BL417 Geological Sciences Phase 2 F100 IGWS East
(F100) Lab Renovations
IU 20250361

ADDENDUM NO. 2
14217

20 March 2026

PARTIAL INTERCONNECTION PLANS - SECOND FLOOR & THIRD FLOOR
E301

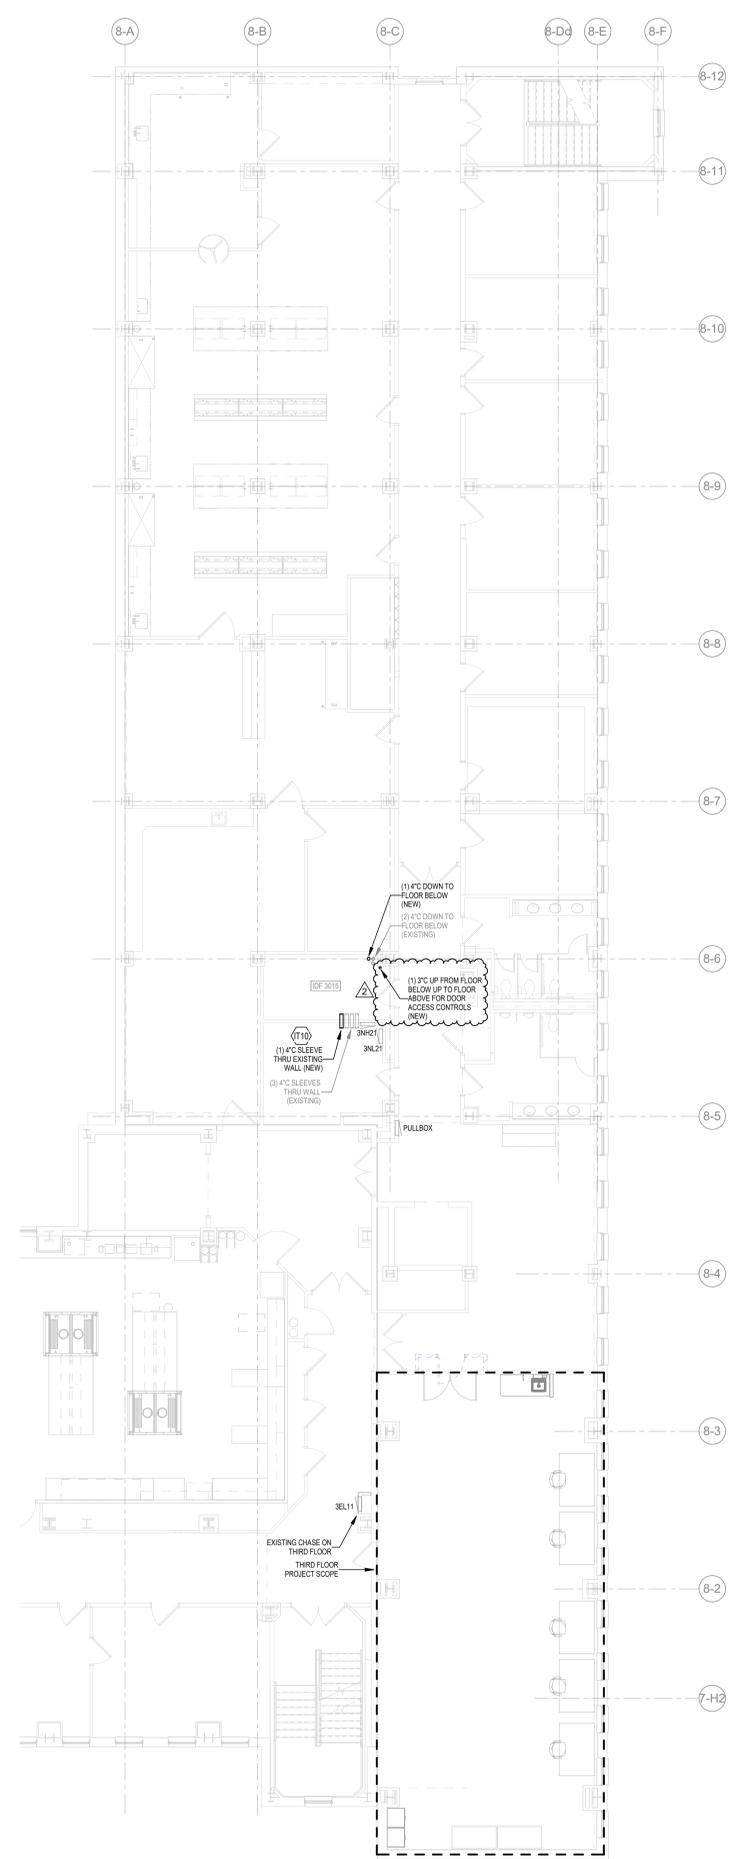
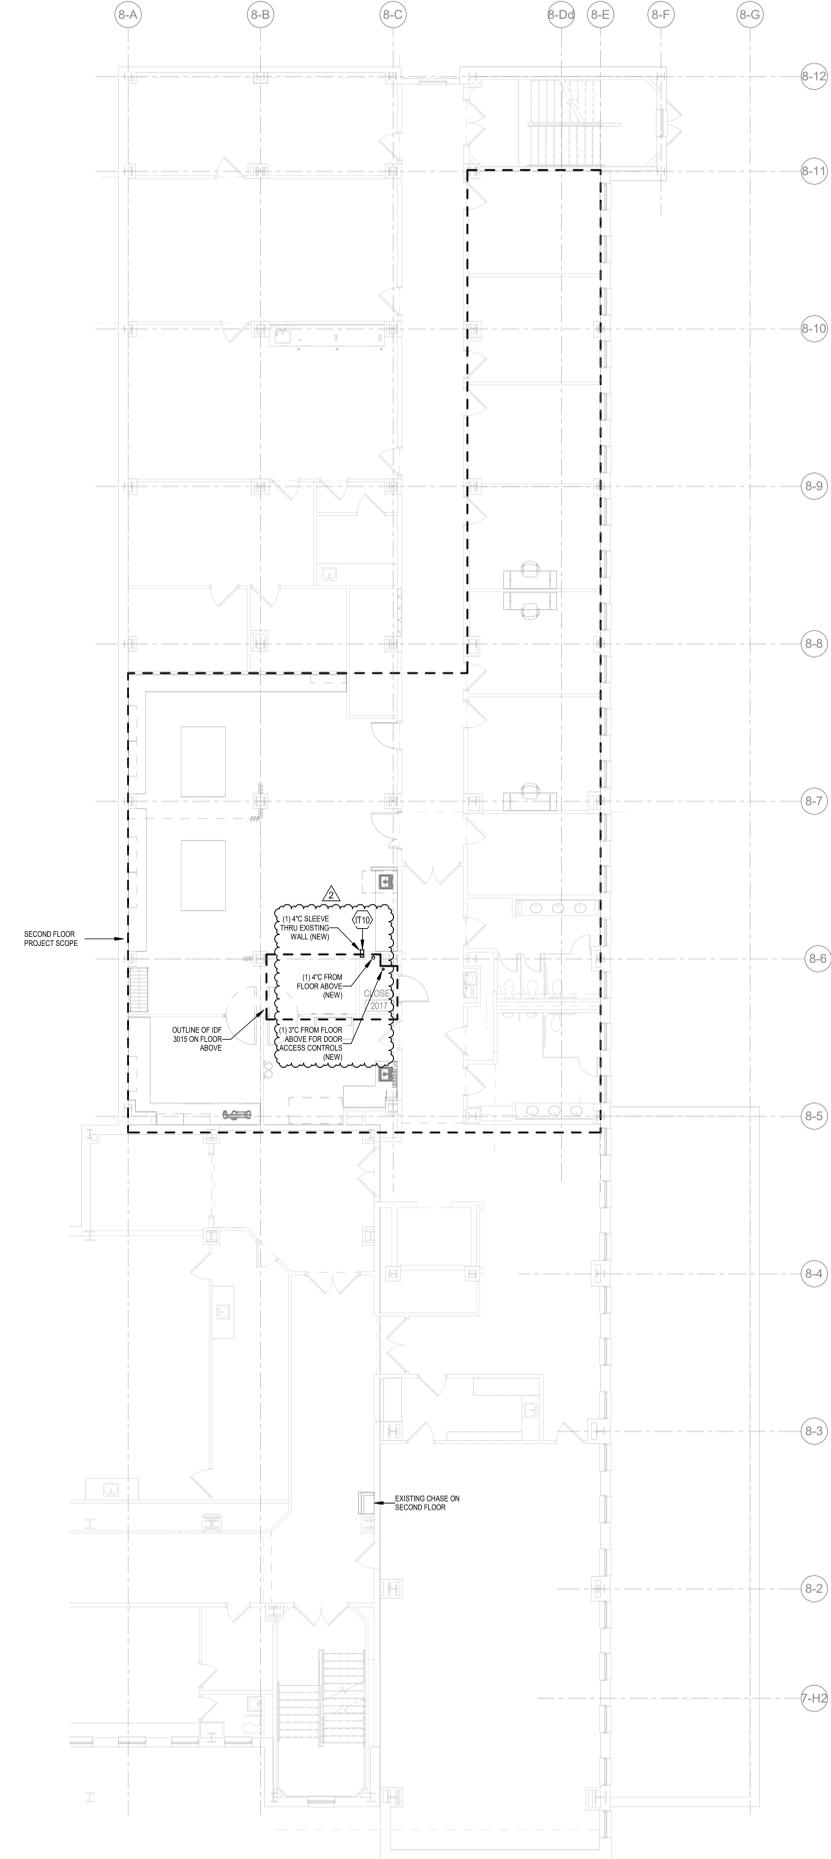
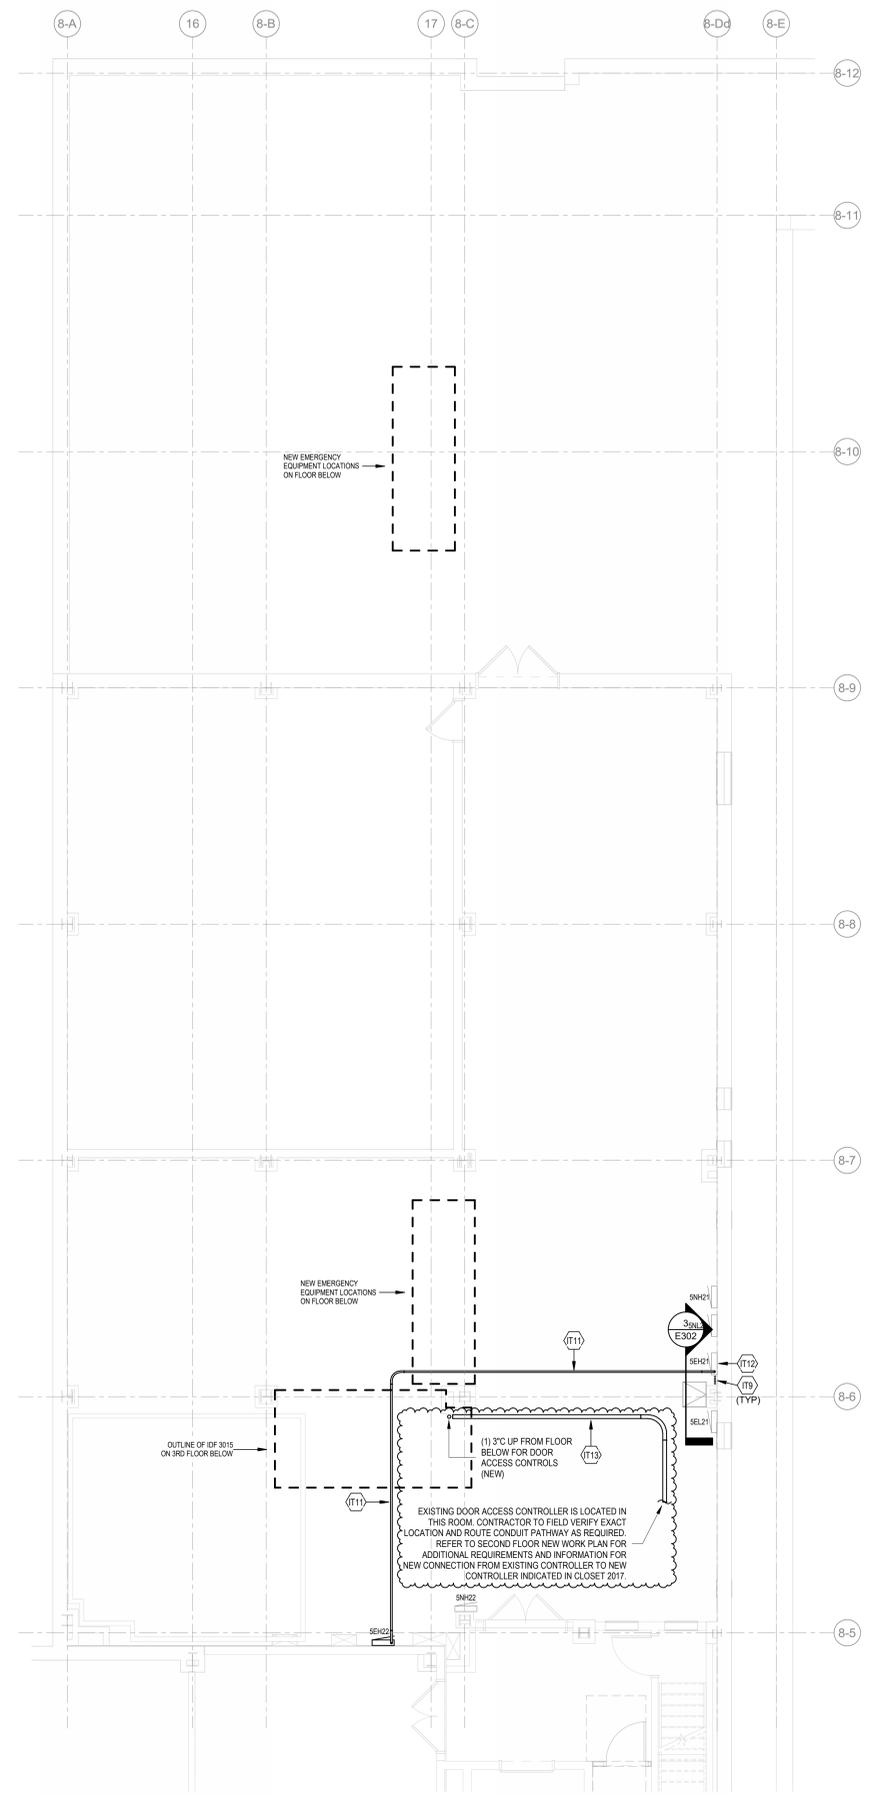
- a. Added location of existing main FACP.
 - b. Revised scope for access controls system connections.
9. Sheet E301 – PARTIAL INTERCONNECTION PLANS - SECOND FLOOR & THIRD FLOOR

- a. Revised scope for access controls system connections.
 - b. Revised scope for data system connections.
10. Sheet E302 – PARTIAL INTERCONNECTION PLANS - FOURTH & FIFTH FLOORS

1 NORTH BASEMENT PLUMBING PLAN
SCALE: 1/4" = 1'-0"

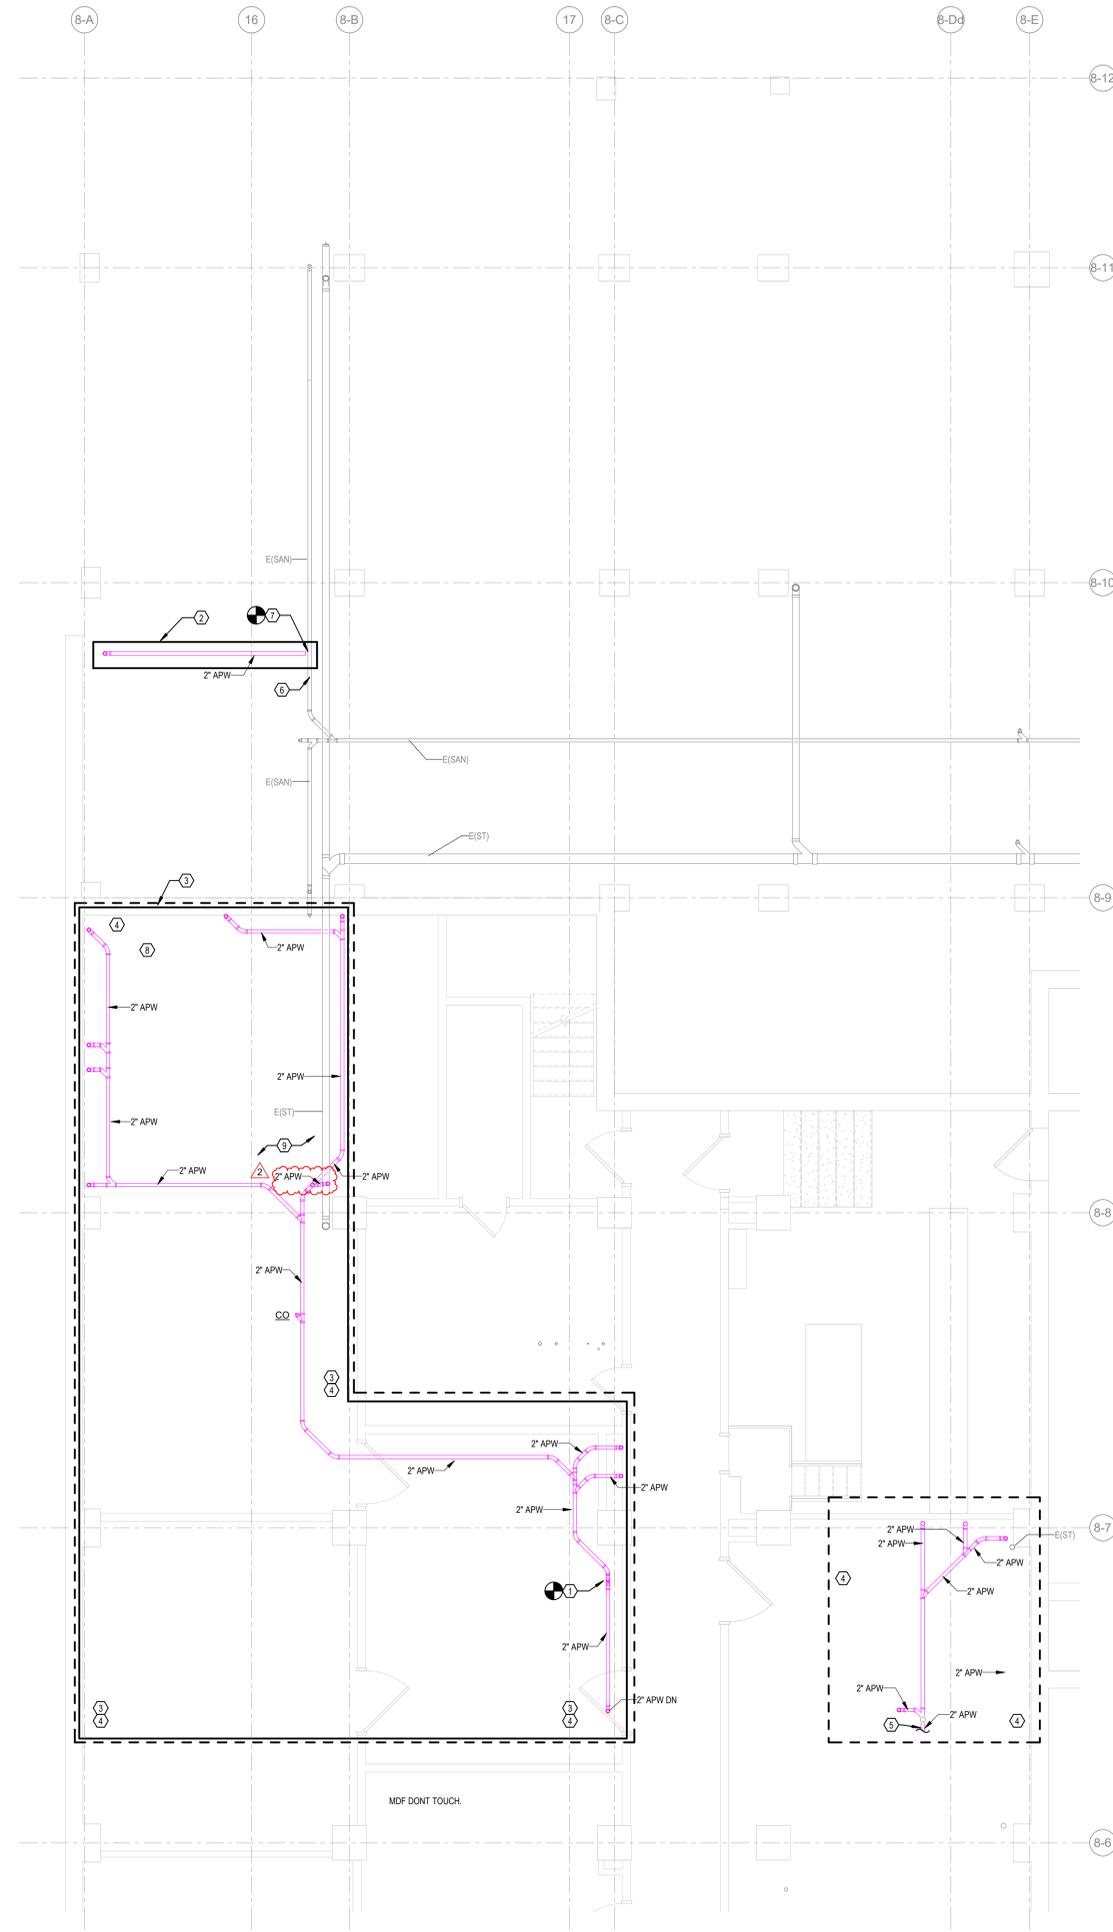
1. Sheet P200 – BASEMENT PLUMBING PLANS
 - a. Added 2" APW piping serving ES/EEW-1 in Teach Lab 1011.
2. Sheet P201 – FIRST FLOOR PLUMBING PLANS
 - a. Added ES/EEW-1 and associated piping and accessories to Teach Lab 1011.

FIRST FLOOR EQUIPMENT PLAN
EQ211

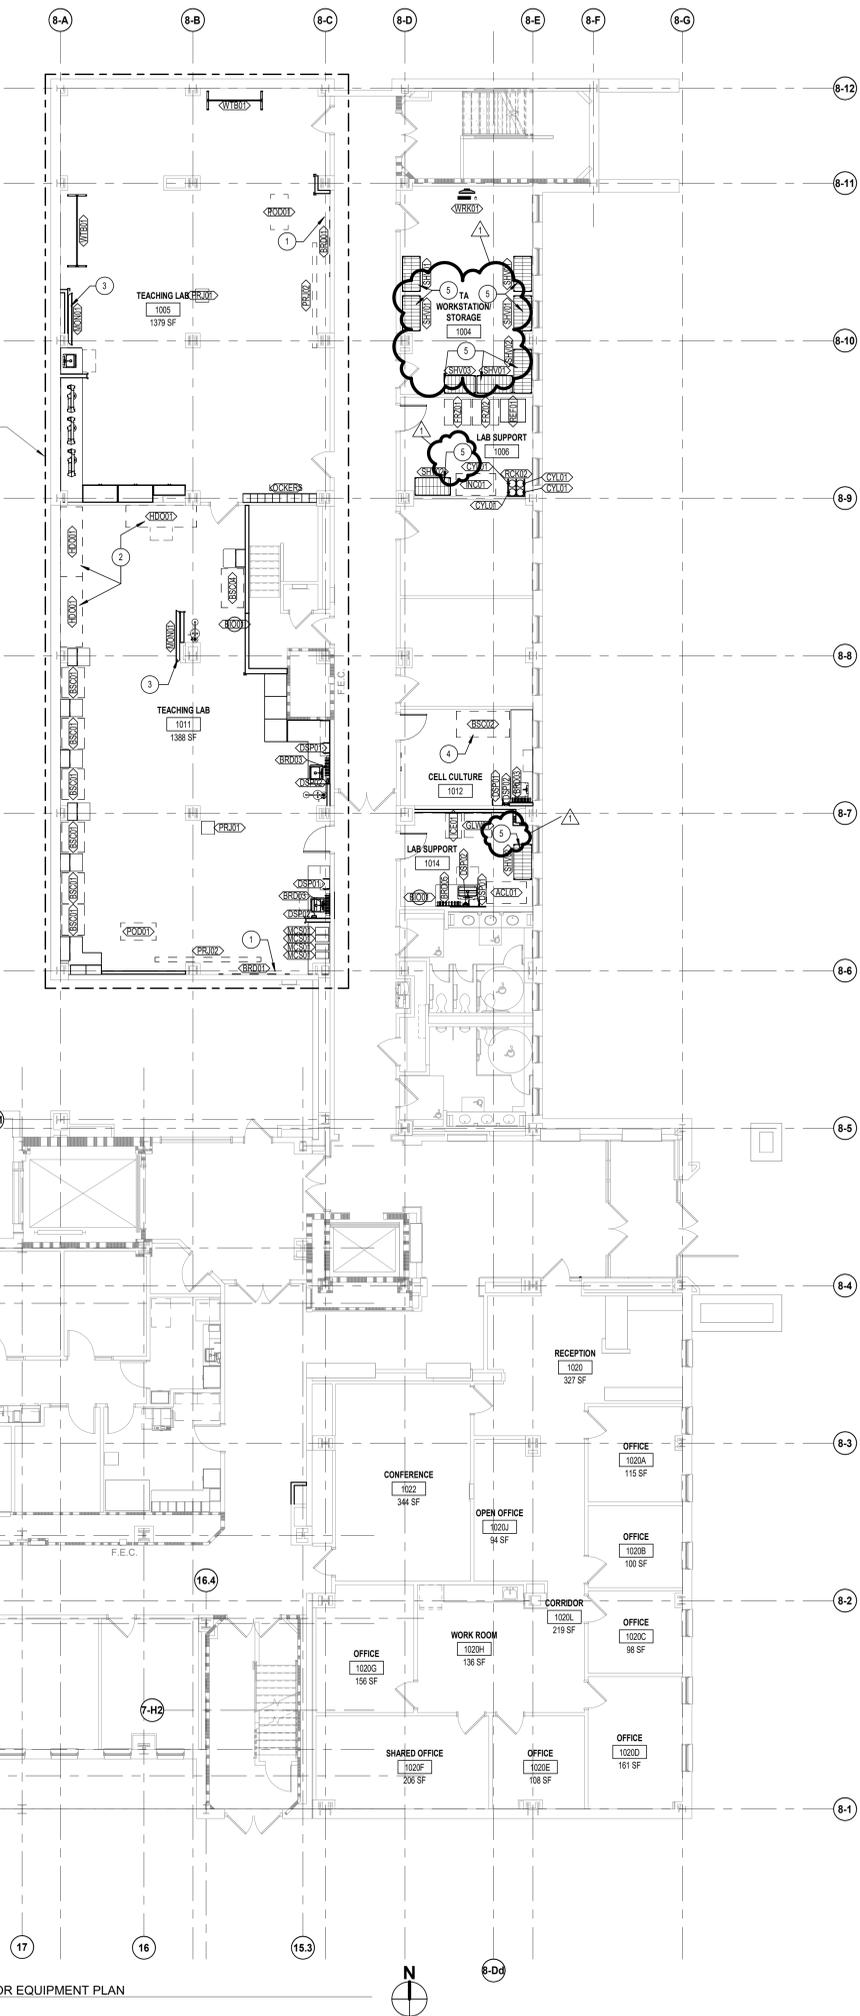
3. Pre-Bid Questions and Answers
 - Q.** Regarding Equipment list on EQ211 & EQ221. There's not enough information for us to pick up the wire shelving (tag SHV01, 02, 03), Glass Boards (tag BRD01), White Board (tag WTB01), and the Wall/Casework Mounted Cylinder Bracket (tag RCK05).

- d. Add section details A821_3 and 4 in their entirety, as shown on attached sheet.
5. Sheet EQ211 - First Floor Equipment Plan
 - a. Add Specific Equipment Plan Note 5 to read as follows:
"5. CFCI WIRE SHELVING WITH 74" POSTS ON 5" CASTERS, AND SOLID STAINLESS STEEL BOTTOM SHELF - SIMILAR TO INTERMETRO INDUSTRIES CORPORATION, SUPER ADJUSTABLE SUPER ERECTA. PROVIDE 2 LOCKING CASTERS PER SHELVING UNIT."

- b. Add Specific Equipment Plan Note 5 to rooms 1004, 1006, and 1014 as shown on attached revised sheet.
 - c. Revise the First Floor Equipment Schedule as follows:

- i. Revise BRD01 Equipment Description to read "96" GLASSBOARD", as shown on attached revised sheet.
 - ii. Revise Responsibility for WTB01 to VFVI. The intent is for these whiteboards to be provided by the Furniture vendor.

- A.** For the wire shelving, refer to Specific Equipment Plan Note 5 on attached revised sheet EQ211. For Glass boards, refer to Section 101100 - Visual Display Units. White boards WTB01 will be provided by the Owner's furniture vendor. For the Wall/Casework Mounted Cylinder Brackets, refer to Section 123553.19.2.11.A Gas Cylinder Brackets.

SECOND FLOOR EQUIPMENT PLAN
EQ221

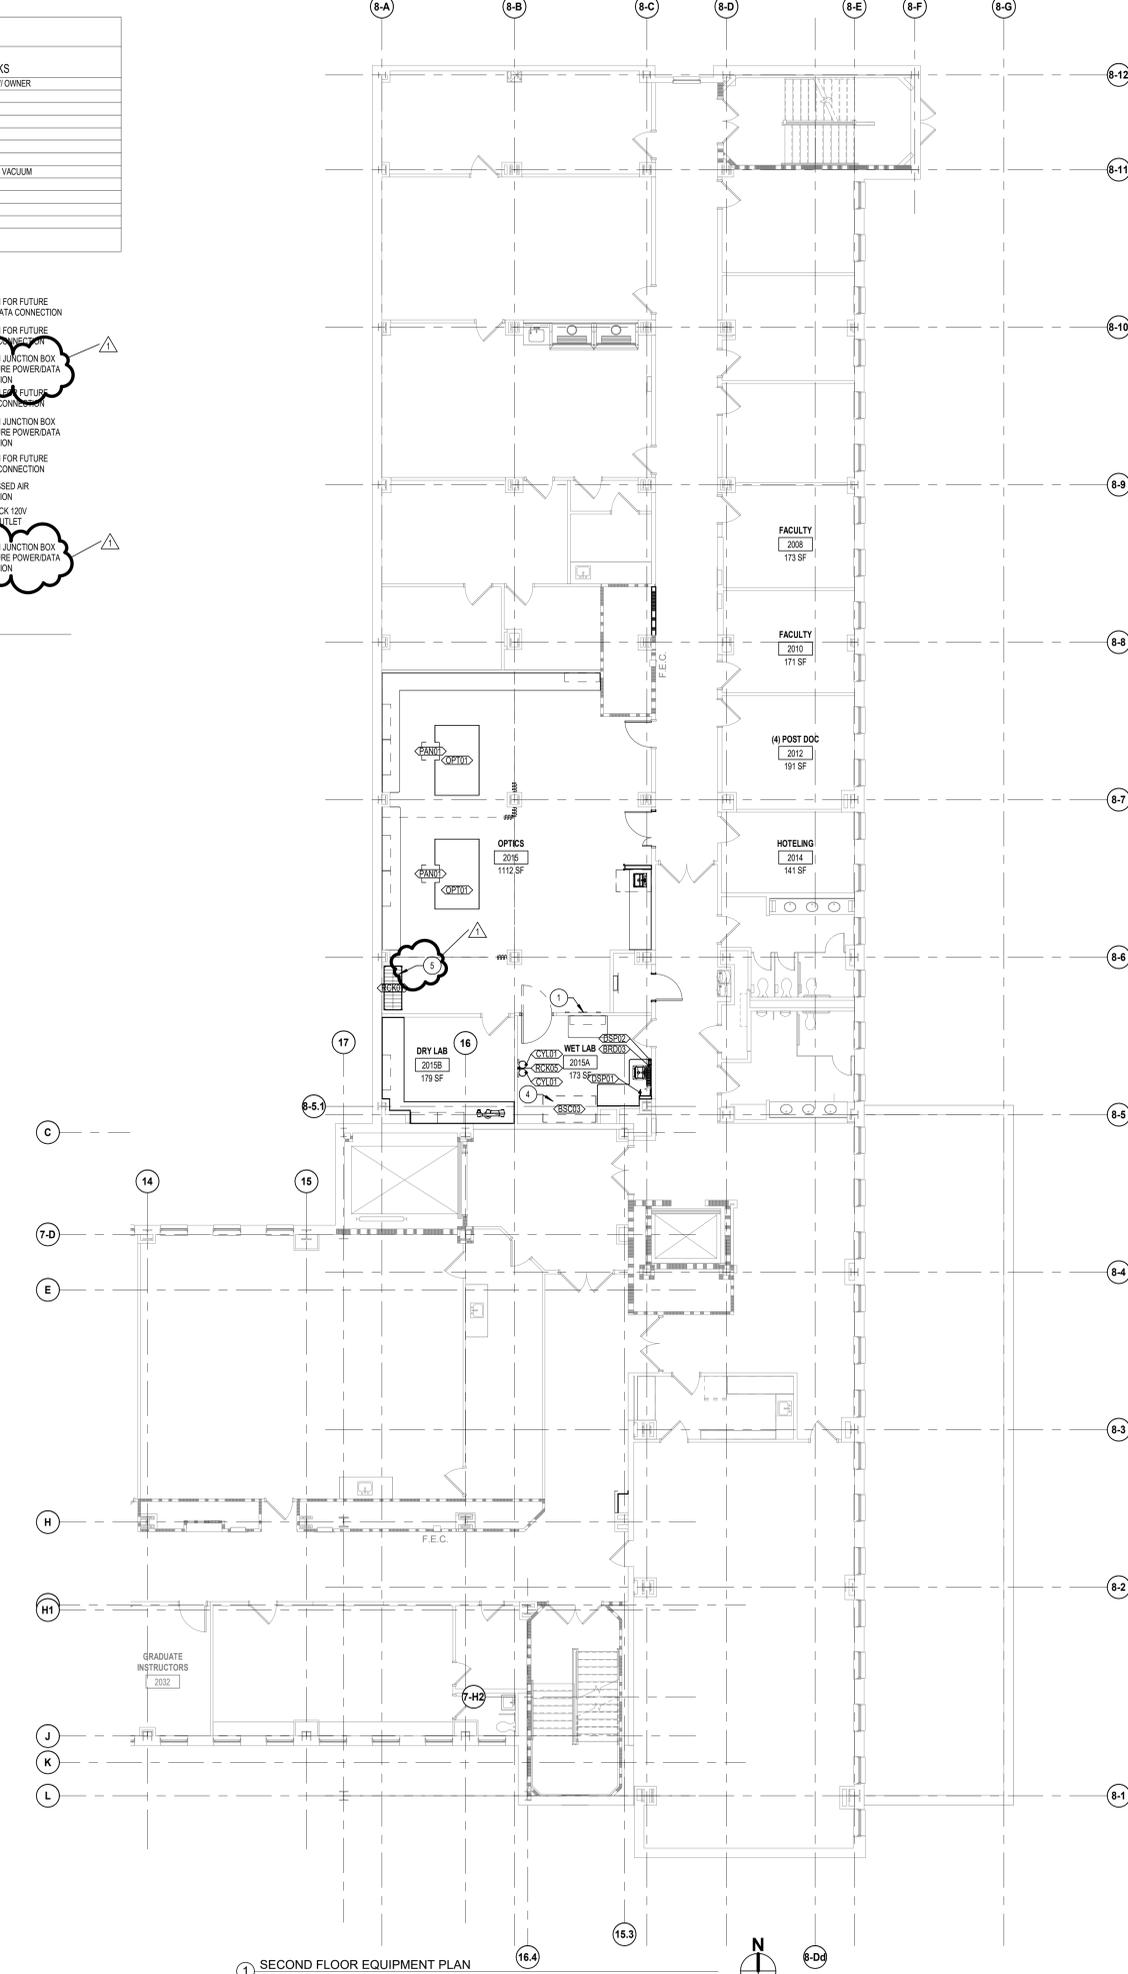
6. Sheet EQ221 - Second Floor Equipment Plan
 - a. Add Specific Equipment Plan Note 5 to read as follows:

-
- “5. CFCI WIRE SHELVING WITH 74" POSTS ON 5" CASTERS, AND SOLID STAINLESS STEEL BOTTOM SHELF - SIMILAR TO INTERMETRO INDUSTRIES CORPORATION, SUPER ADJUSTABLE SUPER ERECTA. PROVIDE 2 LOCKING CASTERS PER SHELVING UNIT.”
- b. Add Specific Equipment Plan Note 5 to rooms 2015 as shown on attached revised sheet.
 - c. Revise Ceiling Service Panel Detail EQ221-2 as shown on attached revised sheet.
 - d. Revise the Equipment Description for BSC03 to include “72” BIOSAFETY CABINET” as shown on attached revised sheet.
7. Sheet EQ231 - Third Floor Equipment Plan
- a. Revise BRD01 Equipment Description to read “96” GLASSBOARD”, as shown on attached revised sheet.
